Reference: **ACCESS CONSULTANCY**
BOWRAL AND DISTRICT HOSPITAL
STATE SIGNIFICANT DEVELOPMENT

Project: Bowral and District Hospital

Document Type: Access Report

Report Number: IAC-454

Figure 3 Access to the site

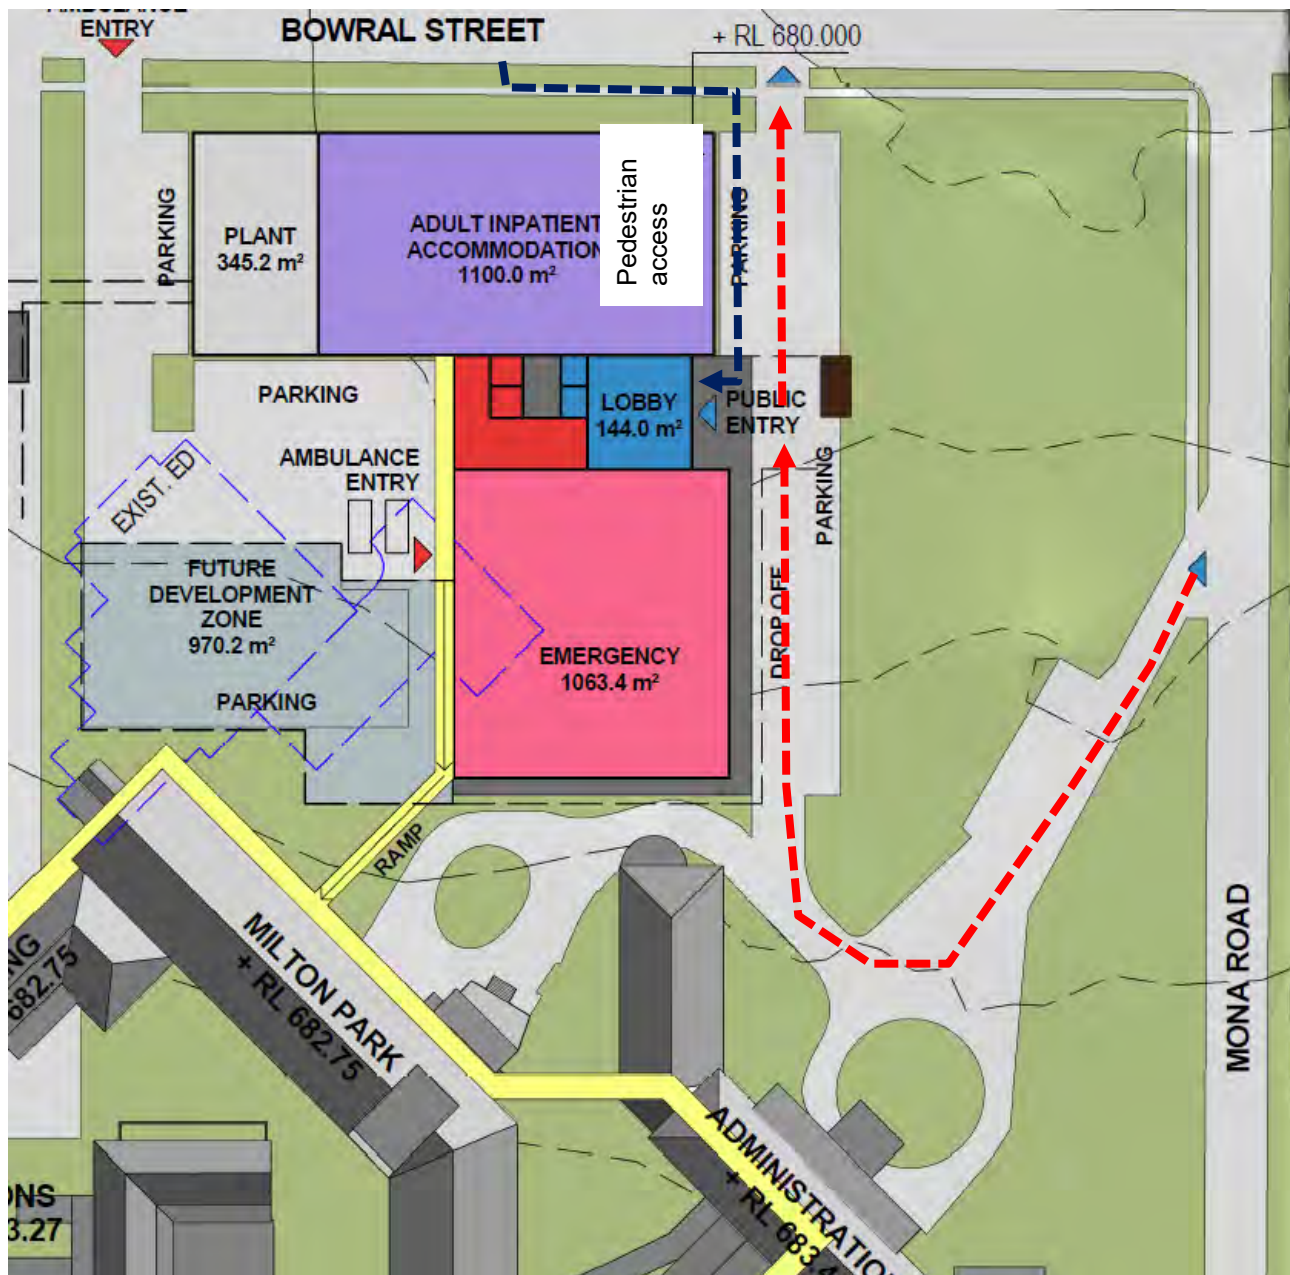
Pedestrian access to the site and the accessible path of travel from the boundary to the Principal Pedestrian Entry is proposed to be from the bus stop located on Bowral Road. The pedestrian accessible path of travel is indicated by the blue dashed line.

It is not intended to upgrade the accessible access to the entries to the existing Administration or Milton Park Buildings as no works are proposed to either of these buildings and accessible access to the hospital will be via the new entry being provided as part of these works.

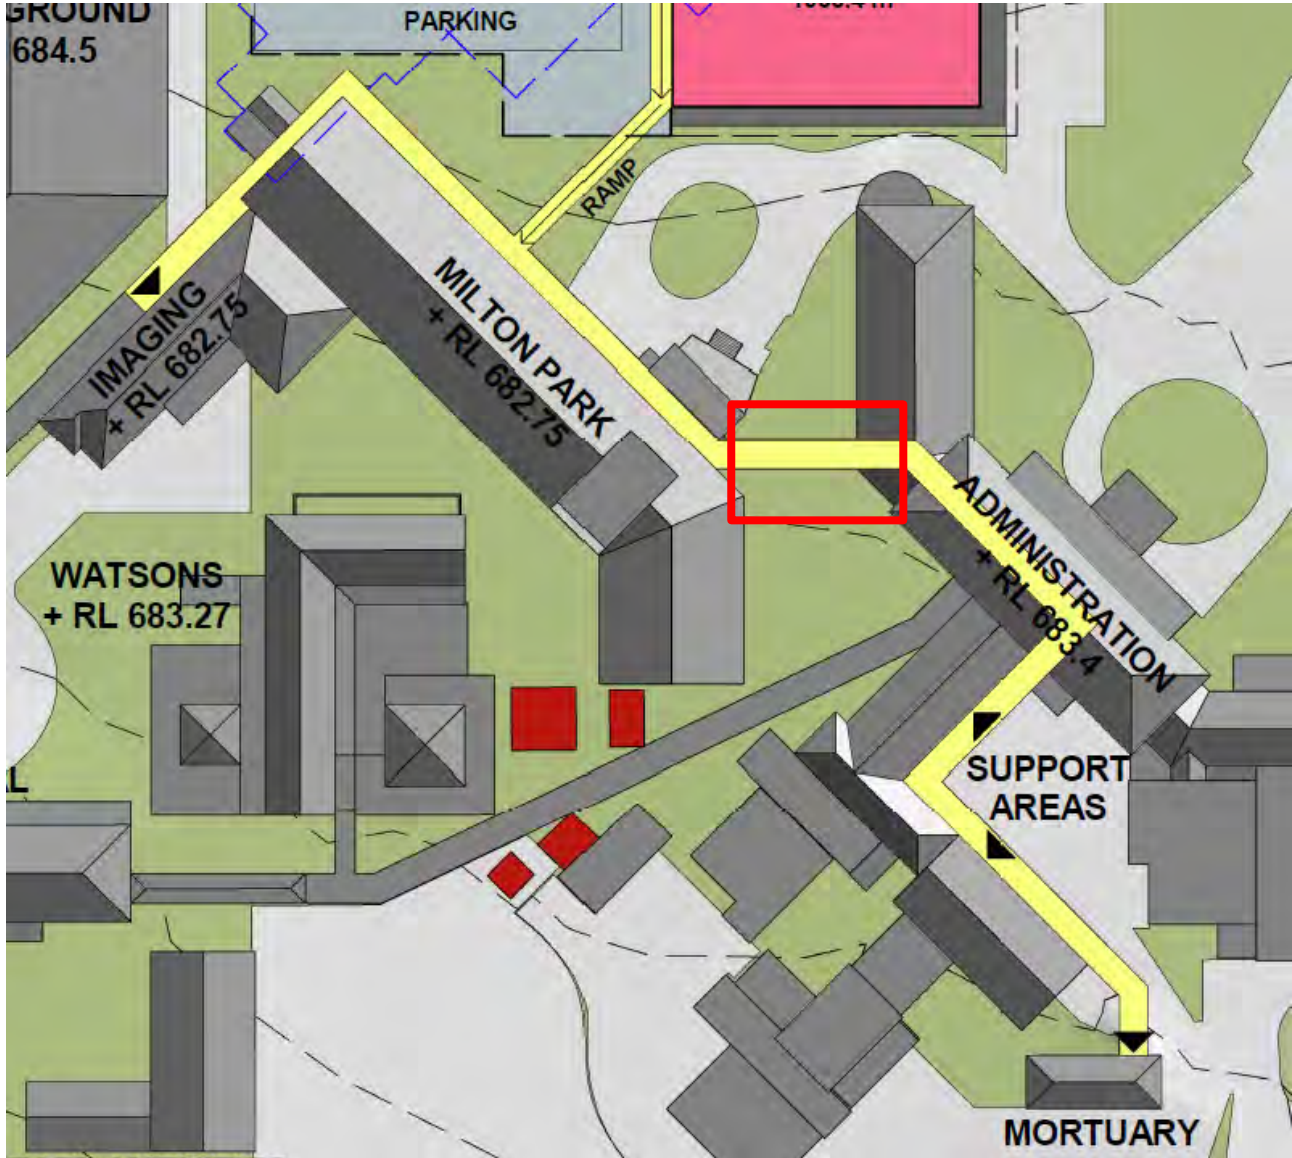
As part of our site visit on 29 July 2016 we walked the corridors that will form the path of travel connecting the new facility with Imaging, The Milton Park Building, Administration, Support areas and the Mortuary as indicated by the yellow path on the extract of the plan provided.

The pathway provides accessible connection from the new facility to all areas. The section of the pathway boxed in red indicates a ramped section where the gradient of sections of the pathway is steeper than 1:14.

It is not proposed to request that this section of the path of travel be upgraded as it is expected that the new facility will reduce the frequency of use of this connection point.

Figure 30 Proposed enabling works Scenario 1

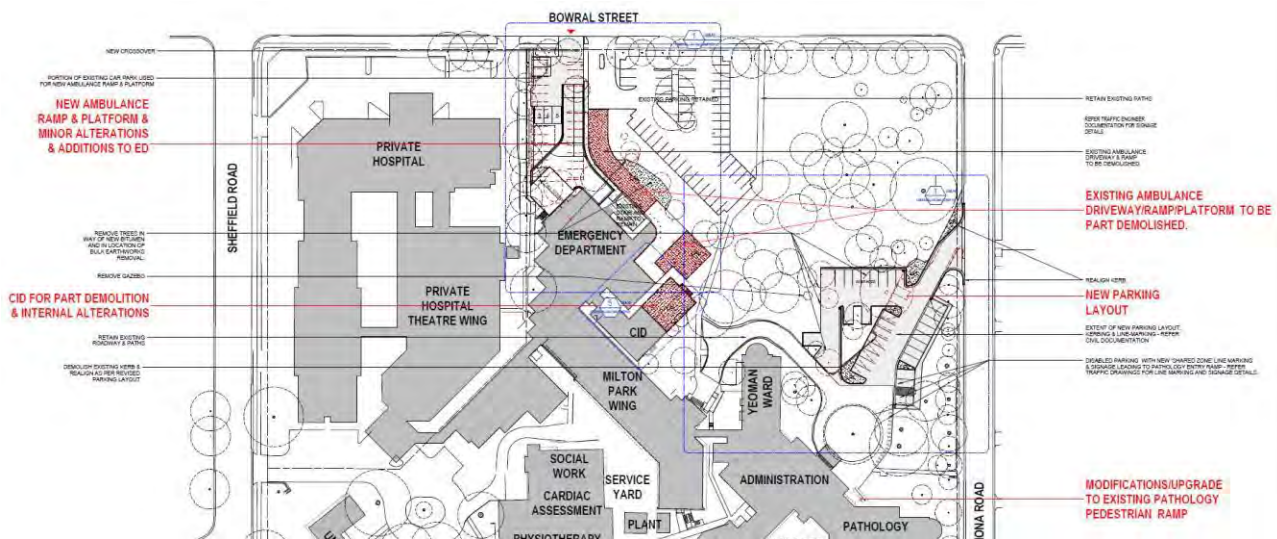
Two scenarios have proposed for consideration. Scenario 1 provides the least intrusive option for the Hospital.

The change in level from the northern carpark is approximately 2.385m. The design length of the 1:14 ramp would need to be in the order of 33.39m + the length of 3 mid landings. The design of the 1:14 ramp would need to satisfy the provisions of Clause 10.3 of AS1428.1.

The minimum width of the 1:14 ramp will need to be not less than 1m between the handrails. It is recommended that the width of the ramp be 1.8m between the handrails. If this is not possible to be achieved, then it is recommended that the landings between the sections of ramps be a minimum of 1.8 x 2m to allow for passing bays for passing wheelchairs in accordance with the provisions of Clause 6.4 of AS1428.1:2009.

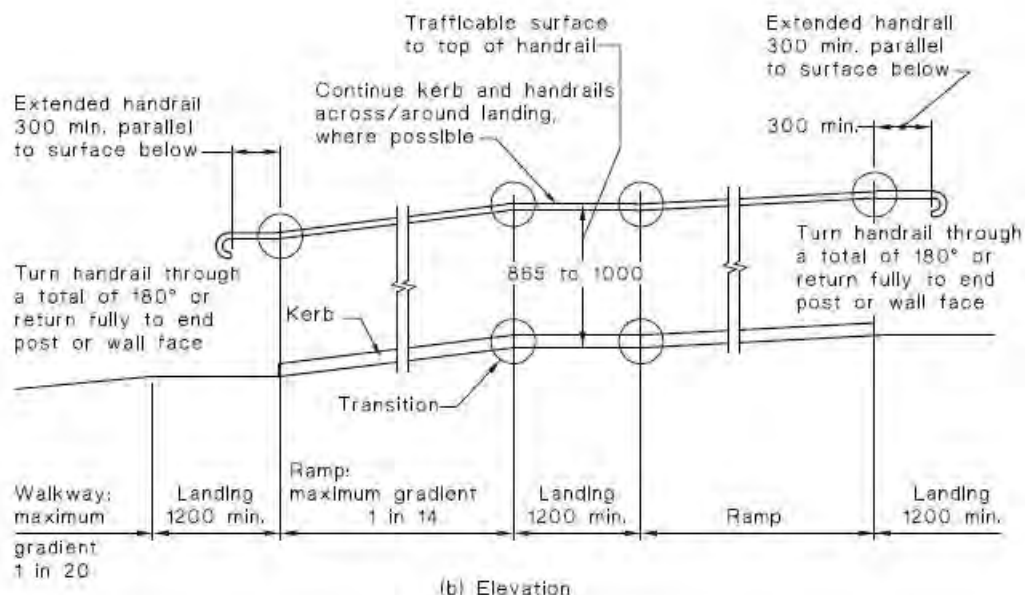
Drawing 130443-MSJ-AR-DWG-EW01102 indicates a scope of works to be undertaken to the ramp to the Pathology Department. The phot following indicates the existing ramp arrangement.

The maximum gradient of the ramp is to be 1:14.

The detailing of the handrails at the bottom of the ramp will need to satisfy the requirements of Clause 10.3(h) of AS1428.1:2009.
